3/22/01

SUBJECT: AMENDMENT TO RLL-1 SERIES REGISTRY

REF. REGISTRY: KY-576-D-113-B

MODEL: RLL-1 SERIES

ATTACHMENT 1 FIGURE A

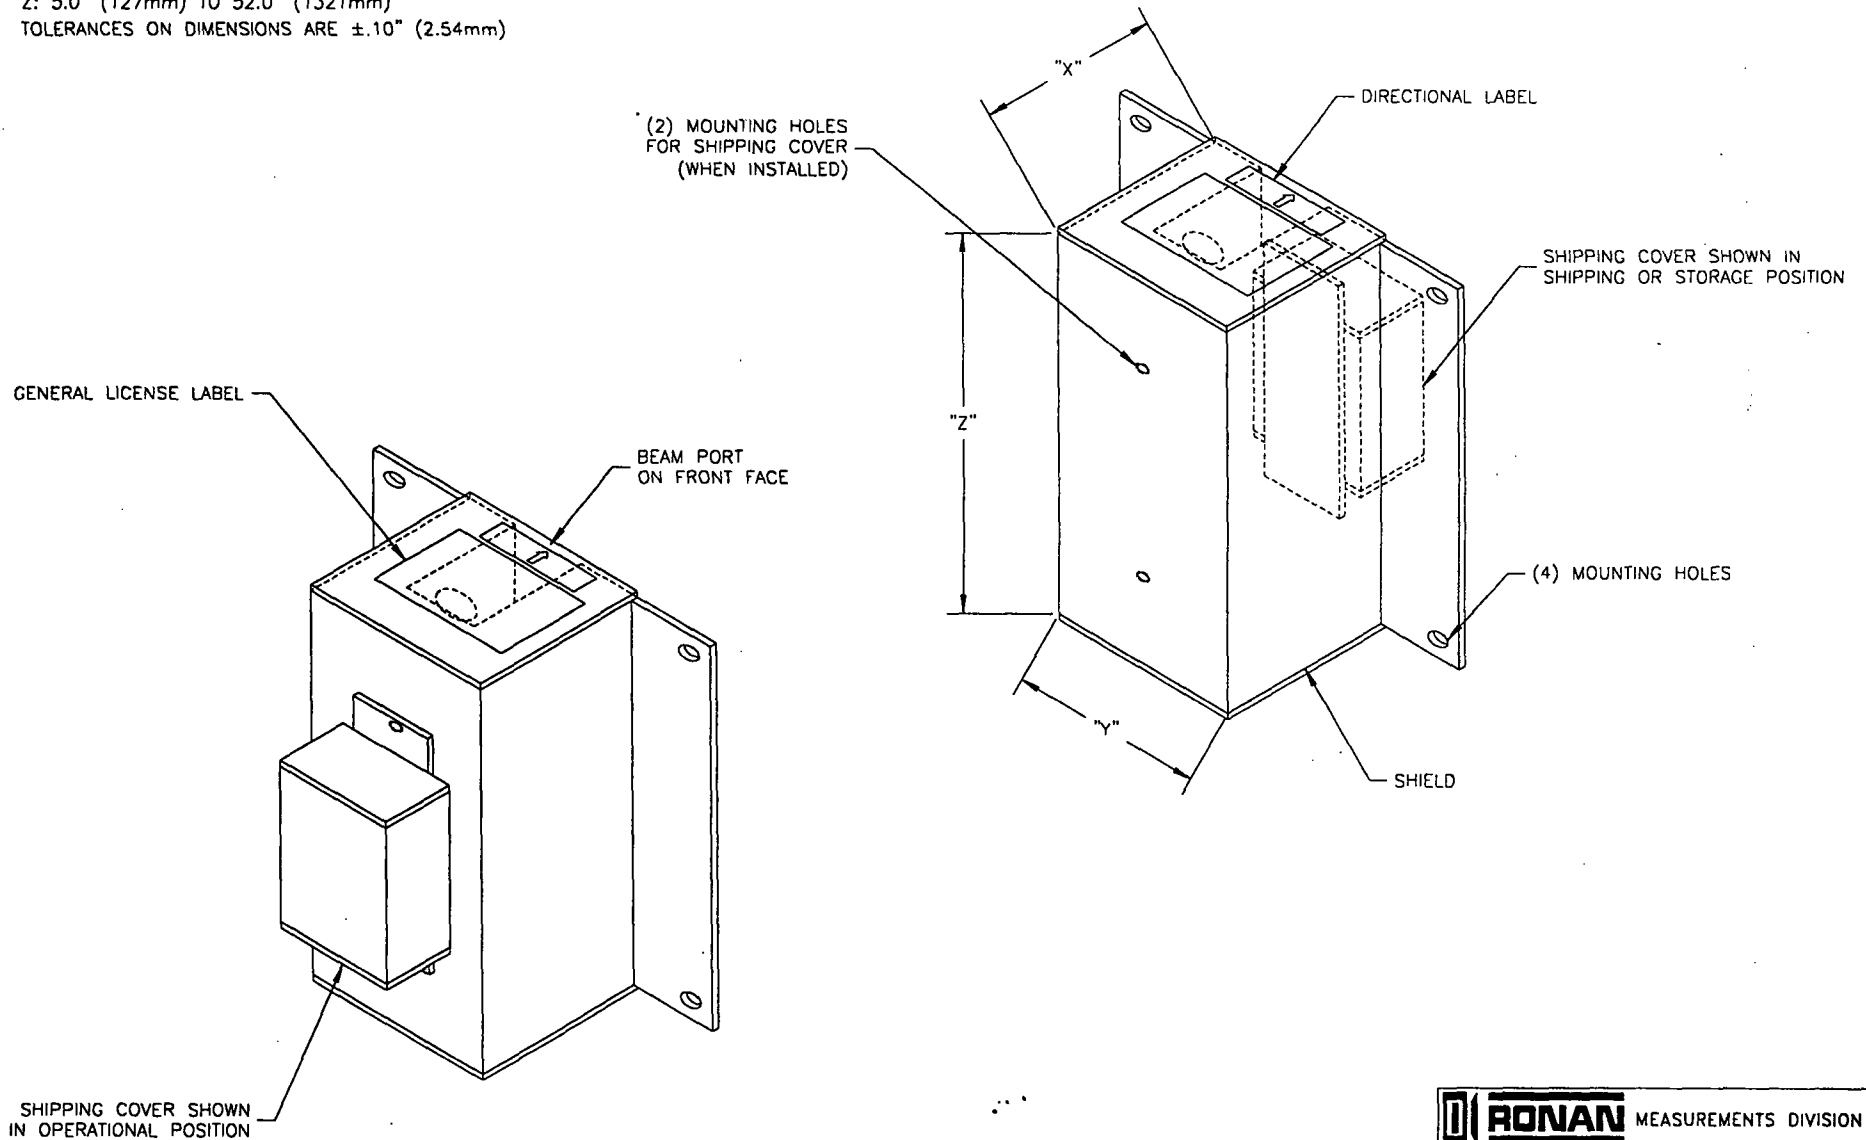
REVISED FIGURE A UPDATED MOUNTING TABS AND RADIATION DIRECTION ARROW.

ATTACHMENT 1 FIGURE A (1)

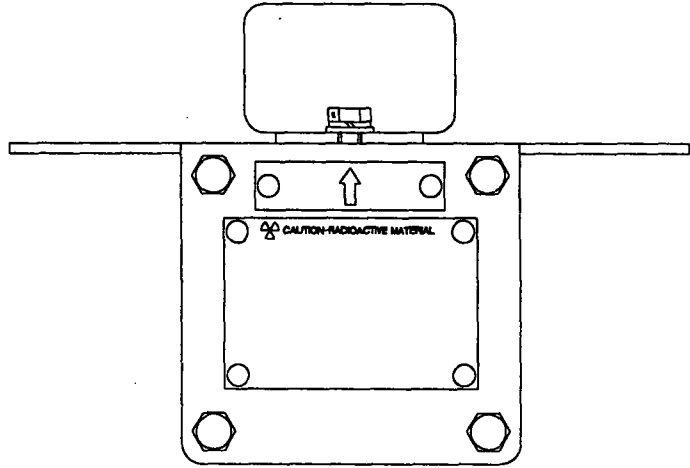
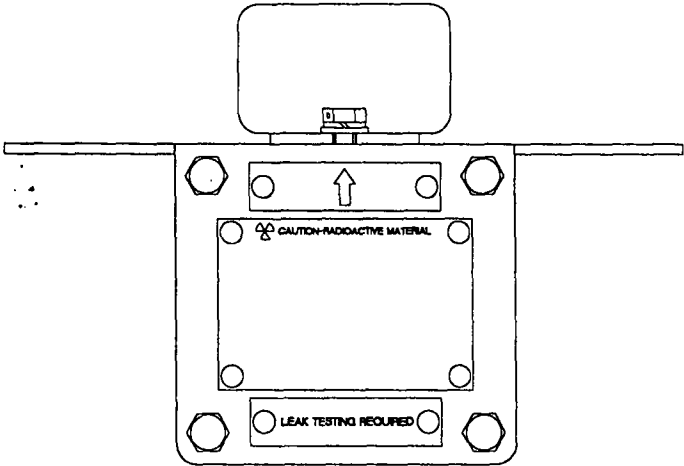
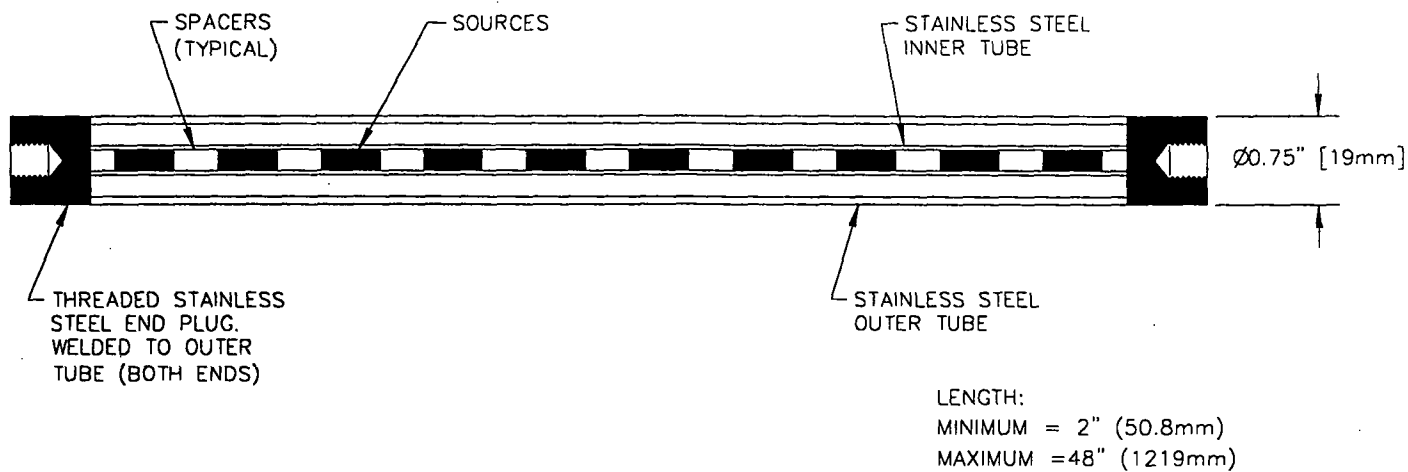
ADDED FIGURE A(i) LABELING INSTRUCTION FOR SINGLE AND MULTIPLE SOURCE CONFIGURATIONS.

ATTACHMENT 1 FIGURE D

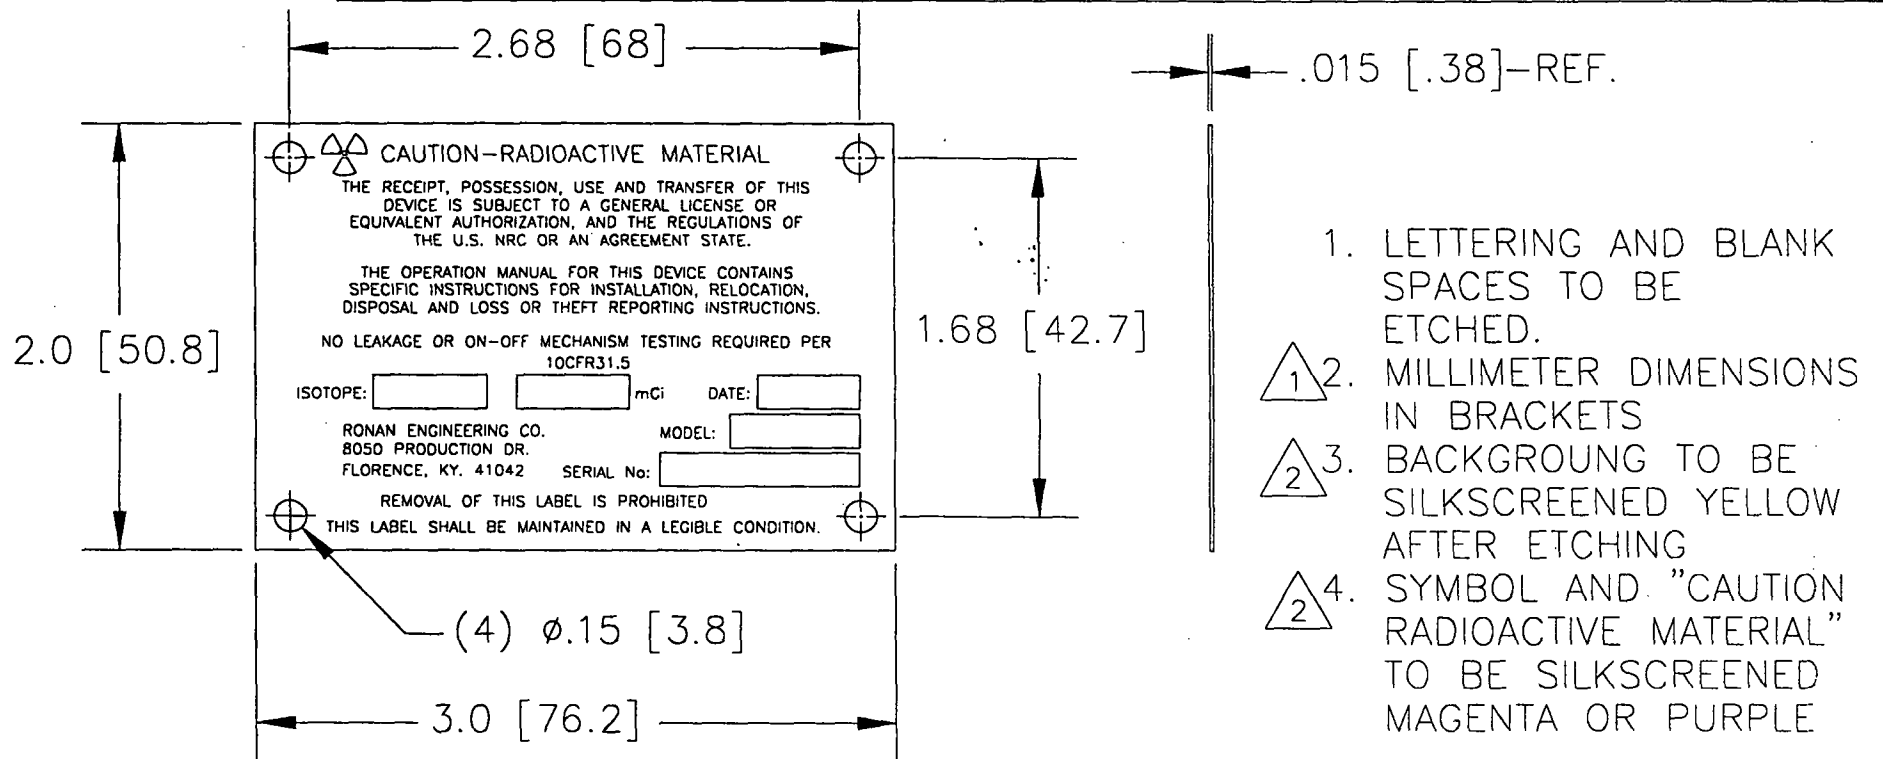
REVISED FIGURE D CHANGED TITLE BLOCK TO SPECIFY; USE WITH MULTIPLE SOURCES LESS THAN 100uCi EACH.

ATTACHMENT 1 FIGURE D (1)

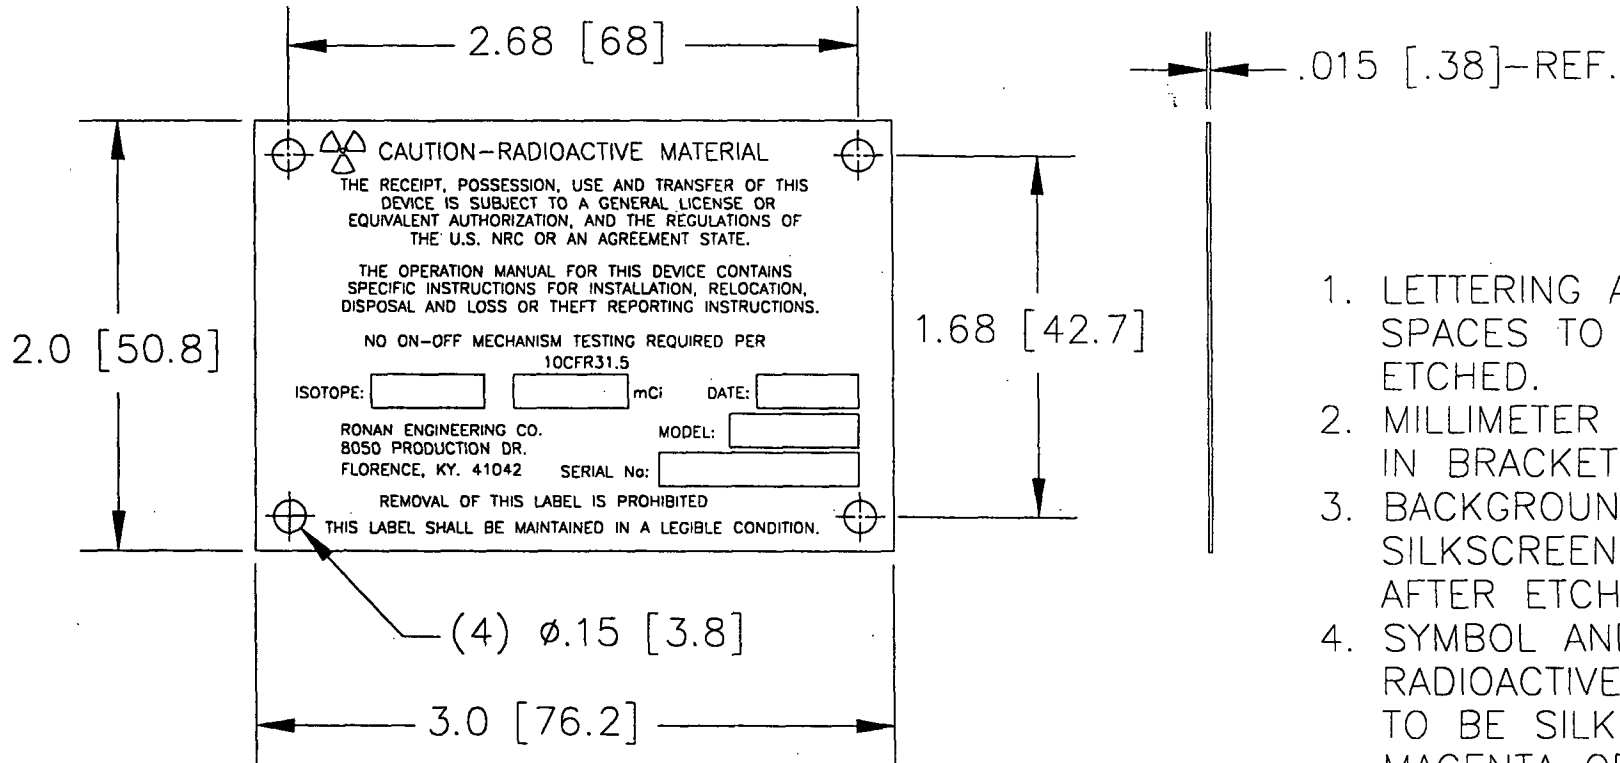
ADDED FIGURE D(i) GENERAL LICENSE LABEL FOR RLL-1 DEVICES WITH A SINGLE SOURCE CONTAINING UP TO 900 uCi CS-137 OR 200 uCi CO-60.

ATTACHMENT 1 FIGURE D (11)

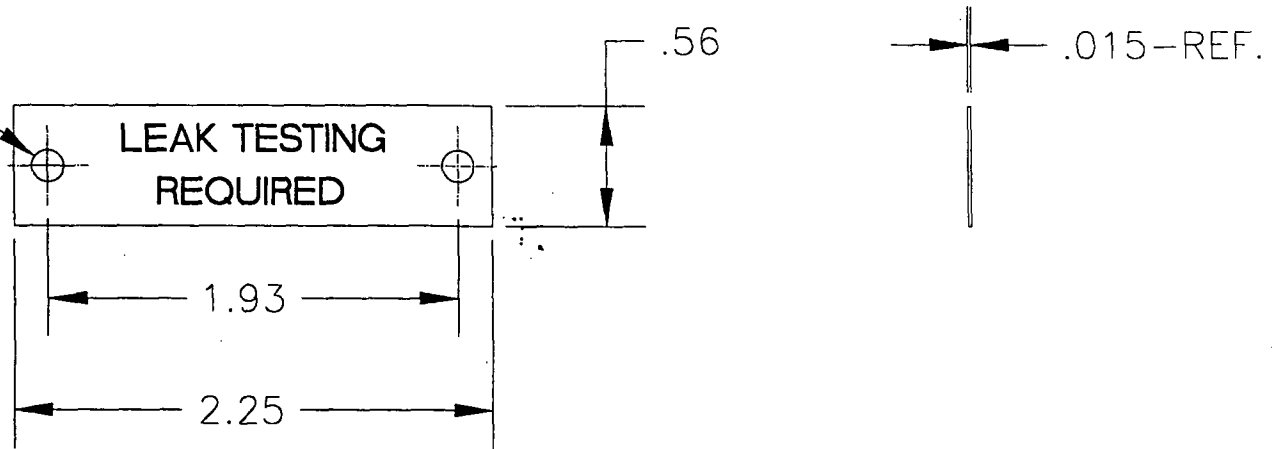
ADDED FIGURE D(ii) ETCHED STAINLESS STEEL LABEL " LEAK TEST REQUIRED"
LABEL TO BE INSTALLED WITH HARDENED STAINLESS STEEL DRIVE SCREWS DIRECTLY BELOW CAUTION LABEL WHEN A SINGLE SOURCE CAPSULE GREATER THAN 90 uCi IS USED.
REF. ATTACHMENT 1 FIGURE A(i).

CUSTOMER:	SCALE NTS	DR. BY AVP APPR. BY
TITLE ISO DISTANCE CURVE: RLL1 WITH SINGLE SOURCE		
DATE 3/20/01	DRAWING NUMBER B-18763-K	REV. 0

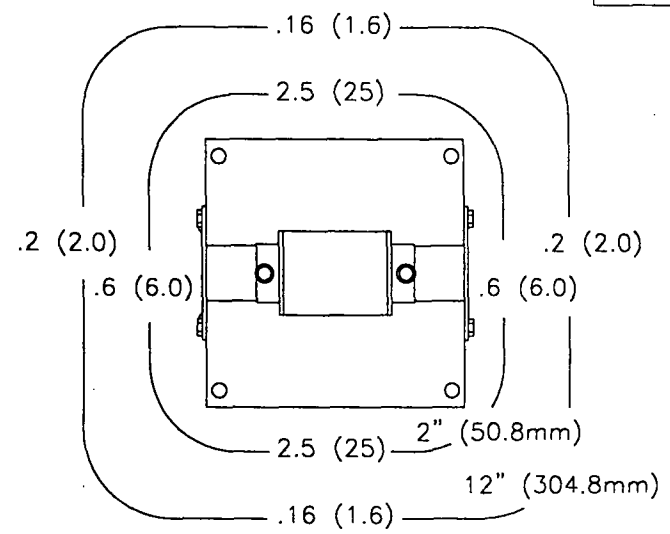
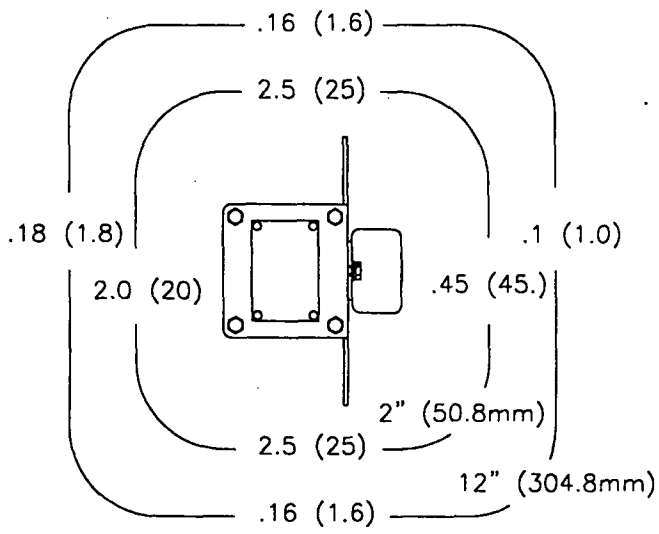
ATTACHMENT 2 ADDED FIGURES D AND D(i) ISO DISTANCE CURVES FOR RLL-1 DEVICE WITH SINGLE 900 uCi CS-137 AND 200uCi CO-60 SOURCE CAPSULES.
